# Service Letter

SL: 40023  
Date: 18 November 2011  
Product: Compressors  
Subject: Turbo Inlet Hose Loose

MODEL	SERIAL CODE
C185WJD-T4i	E43

Figure 1

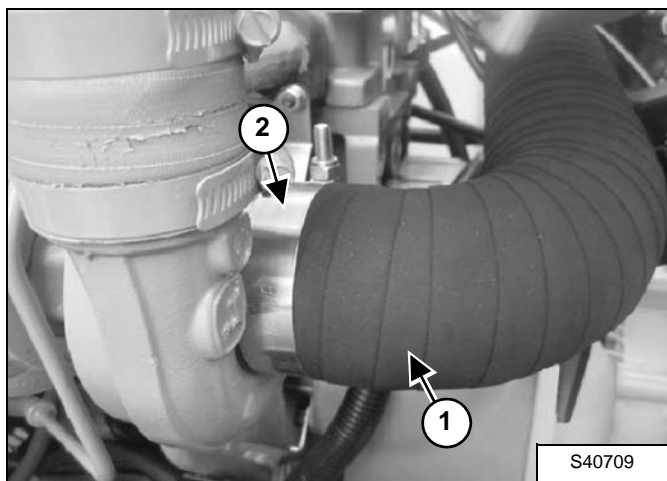
**[Figure 1]** Doosan Infracore has determined that the turbo inlet hose (Item 1) of the compressors listed in this letter may be loose and may slide off the turbo inlet due to wrong orientation of the hose clamp (Item 2).

Therefore the orientation of the hose clamp can be changed to make sure the turbo inlet hose is well tightened.

Figure 2

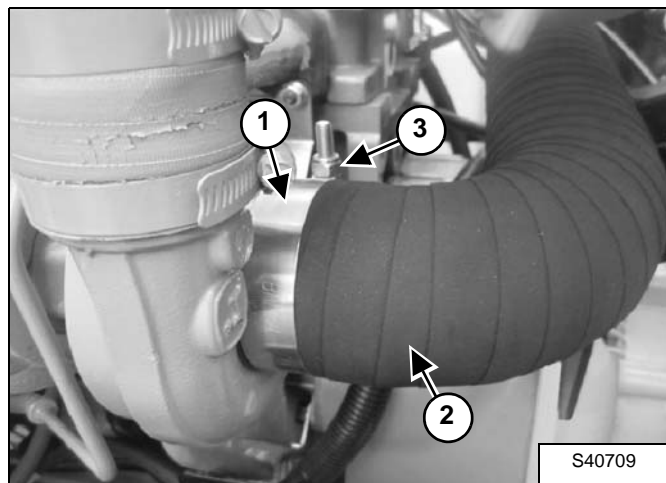
Loosen the clamp (Item 1) and remove the hose (Item 2) **[Figure 2]** and clamp from the turbo inlet.

Reinstall the hose (Item 2) **[Figure 2]** on the turbo inlet by pushing it up against the shoulder of the turbo.

Position the hose clamp with the nut (Item 3) **[Figure 2]** straight up and orientated towards the engine.

Keeping the hose clamp in position, tighten the nut (Item 3) **[Figure 2]** to 8,5 N•m (75 in-lb.) torque. Tighten the hose clamp at the air cleaner end to 8,5 N•m (75 in-lb.) torque.
